Wright Manufacturing, Inc.

Work Inst. Name: **Replaceable Clutch Stop**

Inst. Number: **SVC-SWI-0019**

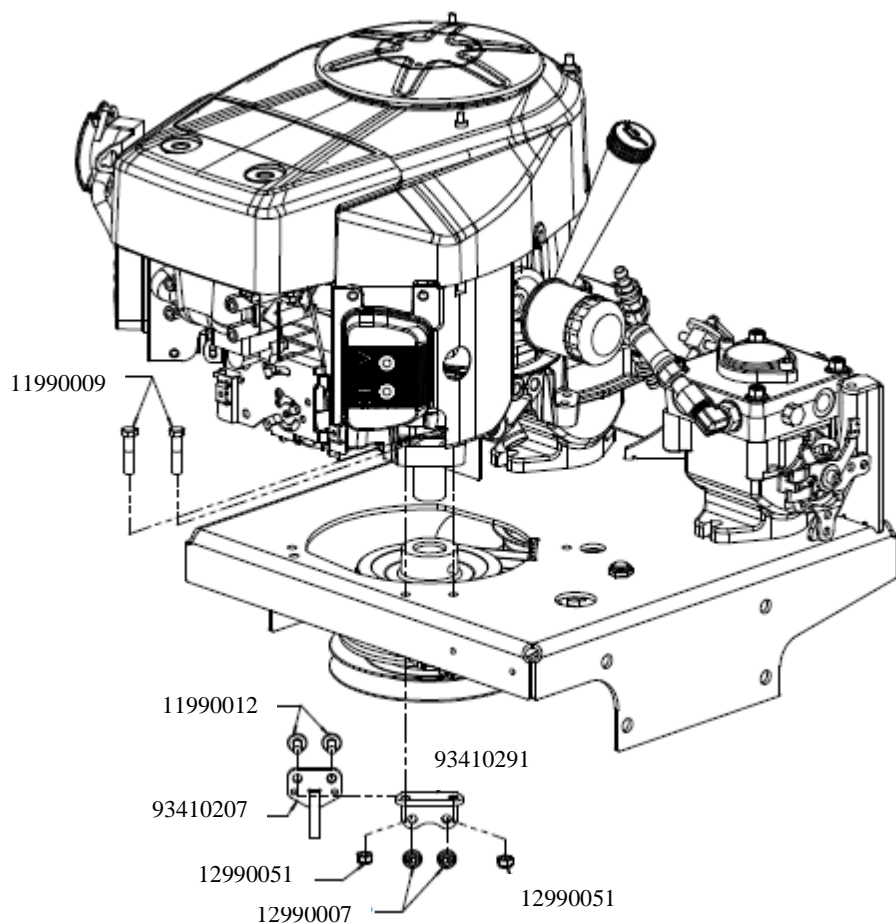
New bolt in clutch stop moves to the forward engine bolt mounting location and utilizes the second stop location on the clutch bell housing. Orientation of the clutch bell housing stays the same.
